As discussed with Anne-Marie Young, please find attached our Submission for DA2021/0006 at 10 Jamieson Parade, Collaroy.

22 April 2021

SUBMISSION [ADDENDUM] TO DA 2021/0006 – REVISED PLANS
Impacts at 8 Jamieson Parade, Collaroy from the proposed redevelopment of
10 Jamieson Parade, Collaroy.

Figure 1 - 9am shadow

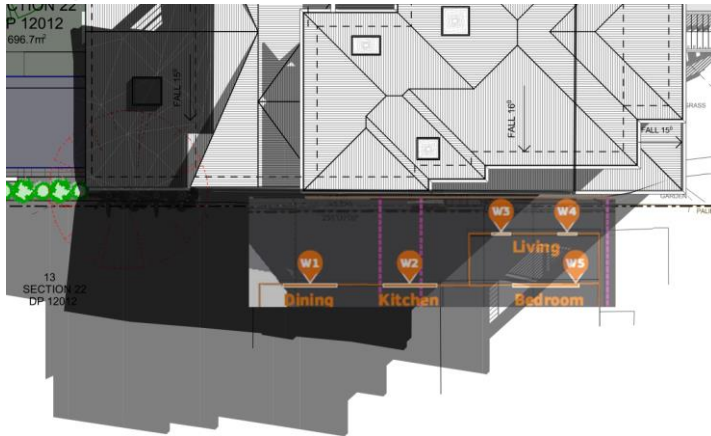
The extent of shading impact is significant and assessed as excessive noting the location of the side boundary envelope exceedance and the extent of proposed development footprint, noting the design exceeds the landscaped area control (calculated to be 31% when excluding the proposed courtyard which does not provide a deep soil area and is elevated above ground level¹) and has excessive site coverage. The design would significantly impact the extent of sunlight to the valued north facing windows of the living, kitchen, and dining rooms within my client's property as noted within images 1-3 below.

The following excerpts are from the shadow diagrams dated March 2021 with the location of the living, kitchen, and dining room windows noted. They show that the living, kitchen, and dining rooms will be in full shade between 9am and 3pm on 22 June.

- Increase the side boundary setbacks at the upper level in to comply with the side boundary envelope control.
- The building footprint be reduced to comply with the landscaped area.
